## Front Wheel Hub – Accumulation Of Excess Grease – Grease Deflector Ring

1997 MY-ON XK8 Range

1998 MY-ON V8 Sedan NA

ILLUSTRATION 1

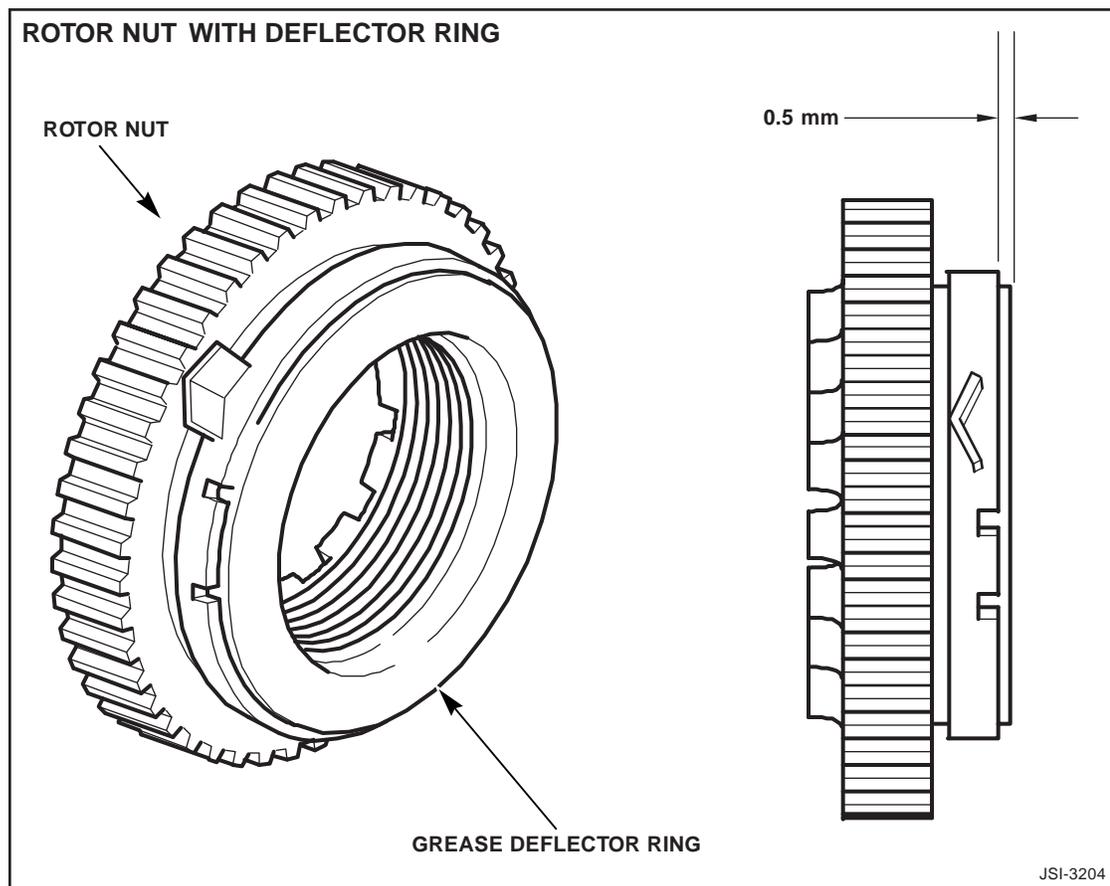
Vehicles after the above VIN are equipped with a nylon grease deflector ring on the rotor nut of each front hub. This ring prevents the build-up of excess grease near the seal which could collect dirt that could damage the seal.

When performing a repair on a 1997 MY-on XK8 that requires removing the rotor nut, install a grease deflector ring during reassembly. 1998 MY-on vehicles must always have the deflector ring reinstalled during any service to the front hub.

The deflector ring is a light interference fit on the nut and must be installed 0.5 mm from the edge of the hub as shown in Illustration 1.
